FORM FOR GENERAL BID – Page 1 of 3
TOWN OF CUMMINGTON – BRIDGE #C-21-005 STAGE ROAD OVER SWIFT RIVER
FRCOG IFB 2025-2153

ADDENDUM 1 BID FORM

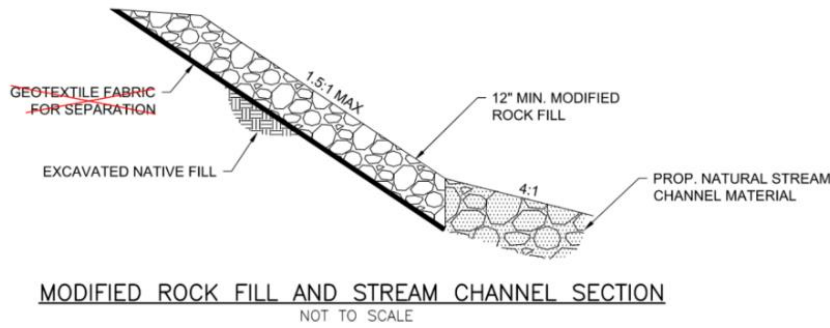
4. Can the caps on the abutments and wingwall be cast in place in lieu of precast (this would especially apply to the sloped wingwalls)?

Answer: The caps can not be cast in place. Please note the sloped wingwall can be stepped.
